Response to the Reviewers' Comments

The authors would like to thank the reviewers for the precious comments and suggestions on the technical contents and presentation of our manuscript “Runtime Power Management of Battery Electric Vehicles for Extended Range with Consideration of Driving Time,” submitted to IEEE Transactions on Very Large Scale Integration (TVLSI.) This revised manuscript has been greatly improved thanks to the reviewers' invaluable advices. We have revised the manuscript faithfully following the reviewers's comments. We include the newly added or significantly modified parts in the revised version of the paper also in Response to Reviewers. We highlight the important technical content changes and set those parts in a red color in the revised paper.

Fig. 2: (a) Range-speed experimental data for Chevrolet Bolt [36] and (b) comparison with simulation results of the proposed EV power model.

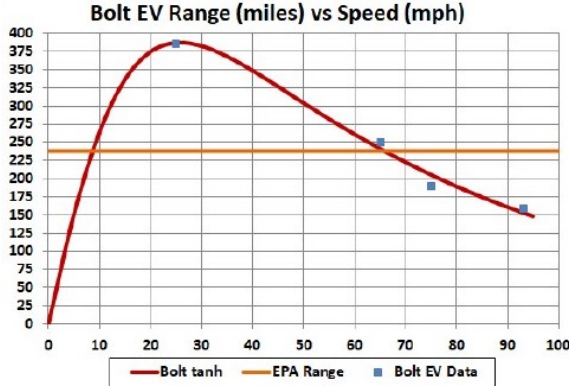
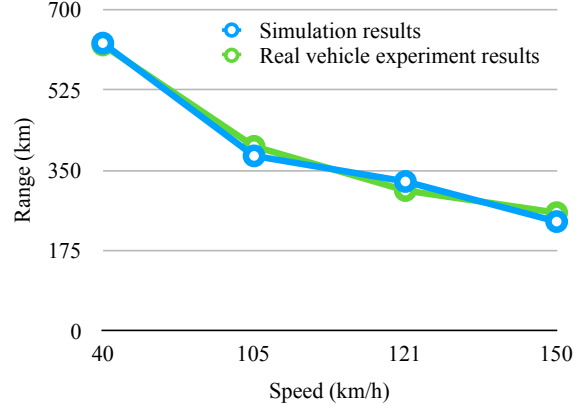
R1-C2 It is not clear how to validate the power model of EV. As the author mentions that accuracy of power model is quite important, it is good to see the power model in this paper can be validated by some real measurement results.

We further evaluate the model accuracy with the range-speed real vehicle experiments as shown in Fig. 2(a) to confirm the derived power models are close enough to the real vehicle measurement data [32], [33], [34], [35], [36]. We refine the coefficients until all the available data values match well.

As a result, the derived EV power model well matches with the range-speed experimental data as shown in Fig. 2(b) as well as the top speed and maximum acceleration setting the aerodynamic resistance, rolling resistance, curb weight, etc. with the known values. The errors in the range-speed simulation is merely 1.4%, the time for 0-to-100 km/h error is 7.8%, and the top speed error is 3.0%, respectively. We revised the manuscript adding the following paragraph with a new figure in Section III.A on page 3 and 4.

We further evaluate the model accuracy with the range-speed real vehicle experiments as shown in Fig. 2(a) to confirm the derived power models are close enough to the real vehicle measurement data [32], [33], [34], [35], [36]. We refine the coefficients until all the available data values match well.

As a result, the derived EV power model well matches with the range-speed experimental data as shown in Fig. 2(b) as well as the top speed and maximum acceleration setting the aerodynamic resistance, rolling resistance, curb weight, etc. with the known values. The errors in the range-speed simulation is merely 1.4%, the time for 0-to-100 km/h error is 7.8%, and the top speed error is 3.0%, respectively.

Fig. 12: Velocity profile comparison with EDP , E^2DP and E^3DP on Serrano Avenue in Anaheim Hills.

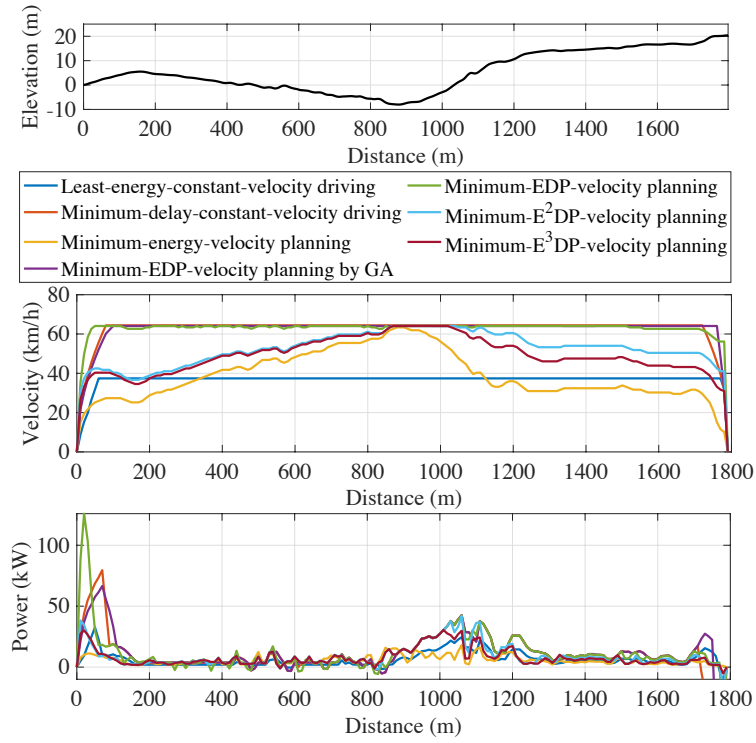
R1-C3 The optimality of the proposed scheduling algorithm is unclear. The author should add several paragraphs to discuss this topic. It is also to see the comparison baseline is well accepted to show the advantage of the proposed algorithm.

We also updated Fig. 12 and Fig. 13:

Fig. 11: Histograms of velocity and acceleration for the proposed energy-aware-velocity planning methods without an acceleration constraint (a) and (b) and with an acceleration constraint (c) and (d), respectively.

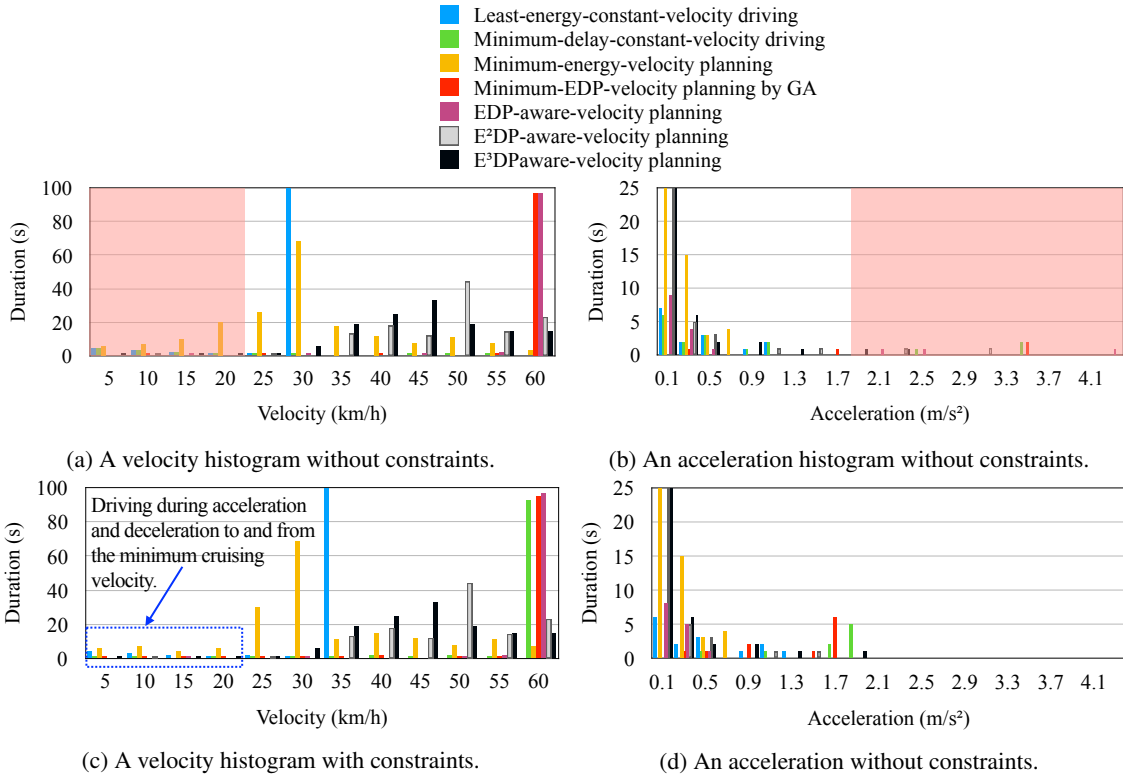
R2-C2 It would be good to have more discussion on the assumptions of the approach and the experiments, e.g., how much can the velocity be changed in practical scenarios without impeding traffic and causing unsafe situations (also depending on the road conditions and whether it is urban or rural environment I suppose). Currently, there only seems to be one constraint on not slower than 10 km/h.

We quantize the velocity and acceleration values and make a histogram to analyze population of velocity and acceleration for the proposed energy-aware-velocity planning methods. Fig. 11(a) and (b) show two histograms of the driving schemes in Fig. 12, which do not have velocity and acceleration constraints. We avoid a cruising

velocity lower than 25 km/h and an acceleration higher than 2.0 m/s^2 in this paper without loss of generality. The acceleration of 2.0 m/s^2 is the same as the maximum acceleration of compact cars designed to be used primarily used in urban areas (13 seconds of 0-to-100 km/h time).

Fig. 11(c) and (d) shows the velocity and acceleration histograms with the constraints. Once we run the DP for the first time without constraints, we analyze the histogram, adaptively determine the minimum cruising velocity and maximum acceleration constraints, and run DP again. We keep the same constraints for online recomputation whenever unexpected interrupts occurs.

We also enforce the minimum acceleration not lower than 1.0 m/s^2 when the EV starts from a stop sign or a traffic light until the velocity reaches to the minimum cruising velocity not to bother traffic flow. The acceleration of a 1.0 m/s^2 exhibits 6 second delay to reach 25 km/h. The maximum speed is bounded by the speed limit of each road benchmark.

Fig. 8: Altitude changes in the real road benchmarks.

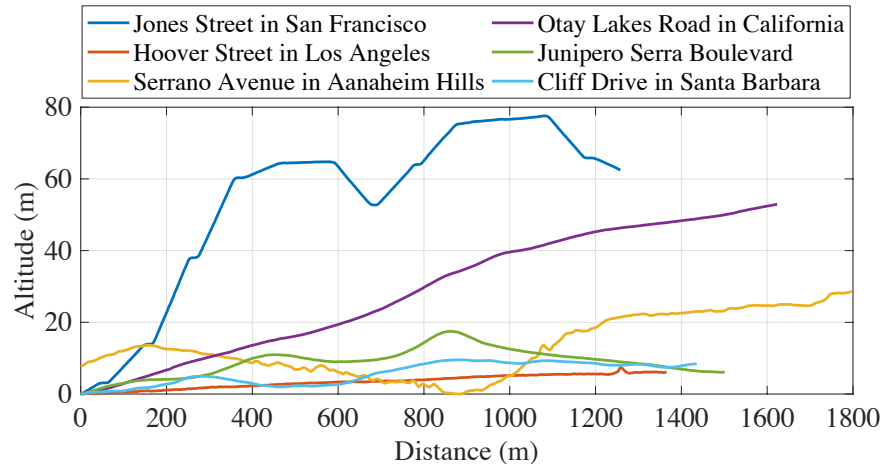
R2-C3 Related to the last point, it would be good to have more discussion on the road benchmarks, e.g., how they are generated and how representative they are. The optimization results significantly depend on road slope. It would be good to use a variety of real road segments for testing.

R2-A3 We appreciate the reviewer's comment. We replaced the previous synthetic road benchmarks with the real road benchmarks. We made six new real road benchmarks from various locations in California. The first three roads are in cities. Jones Street in San Francisco and Hoover Street in Los Angeles are two representative city landscapes such as hills and flat roads, respectively, and Cliff Drive in Santa Barbara is a mixture of those. The second two roads are in mountain areas: Serrano Avenue in Anaheim Hills and Otay Lakes Road in San Ysidro Mountain in California. The last road is Junipero Serra Boulevard connecting San Francisco and San Jose. The details of road data is summarized in Table II, and Fig. 8, which visualize the altitudes of the road benchmarks. We also revised all the associated contents with the new real road benchmarks.

We choose six roads from various locations in California and make real road benchmarks. The first three roads are in cities. Jones Street in San Francisco and Hoover Street in Los Angeles are two representative city landscapes such as hills and flat roads, respectively, and Cliff Drive in Santa Barbara is a mixture of those. The second two roads are in mountain areas: Serrano Avenue in Anaheim Hills and Otay Lakes Road in San Ysidro Mountain in California. The last road is Junipero Serra Boulevard connecting San Francisco and San Jose. The details of road data is summarized in Table II, and Fig. 8, which visualize the altitudes of the road benchmarks.
